Design + Sustainability Advisory Panel Meeting Report – Date 16 December 2021

2 - DA2021 2257 - 42 North Steyne & 75 The Corso MANLY

PANEL COMMENT AND RECOMMENDATIONS

Figure 1 Extent of Manly Heritage Conservation Area and diagram showing the site boundary (black) and street addresses (red)

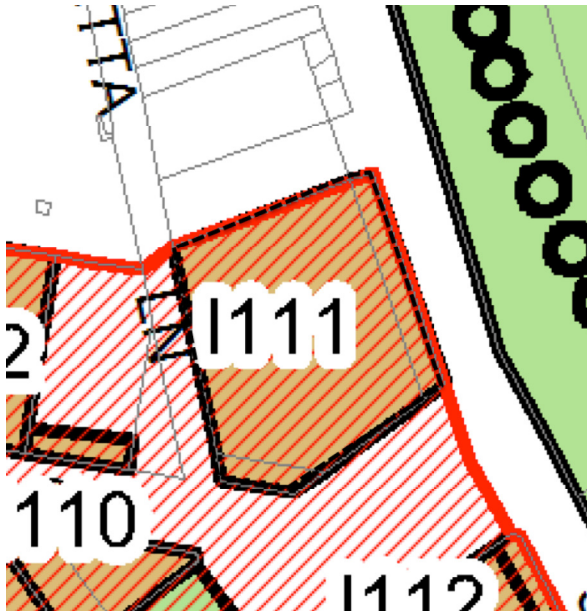
There appears to be some disagreement about whether No 41 is a heritage item or not.

*The 3-storey building at No. 41 North Steyne (to the north) is part of the hotel site. This a Federation Free style building with a café to the ground floor, pairs of timber shingled projecting balconies above, and a tall parapet featuring semi-circular blind arches. **This building is not heritage listed (incorrect) and is outside the Manly Town Centre Heritage Conservation Area. (incorrect)***

This does not align with the LEP listing that clearly states the heritage item is Manly Hotel Steyne 75 The Corso Lots 100, 101 and 102, DP 1069144

(<https://legislation.nsw.gov.au/view/whole/html/inforce/2016-01-27/epi-2013-0140#sch.5>) (refer to Figures 1,2,3)

The Panel notes Council’s Heritage Officer is not supportive of the demolition of the heritage listed building at 41 North Steyne (Item I111).

1. Resolve the definitions of the extent of the heritage The CMP consistently refer to 'the building when in fact the hotel comprises more than the single building as noted in the listing.
2. Determine on what basis all parts of No41 have been given a "D" level of significance CMP p29 with no mention of the façade or balconies. It is not clear why the eastern and southern facades of No 75 are given a 'B' ranking when No41 "remains highly intact externally".
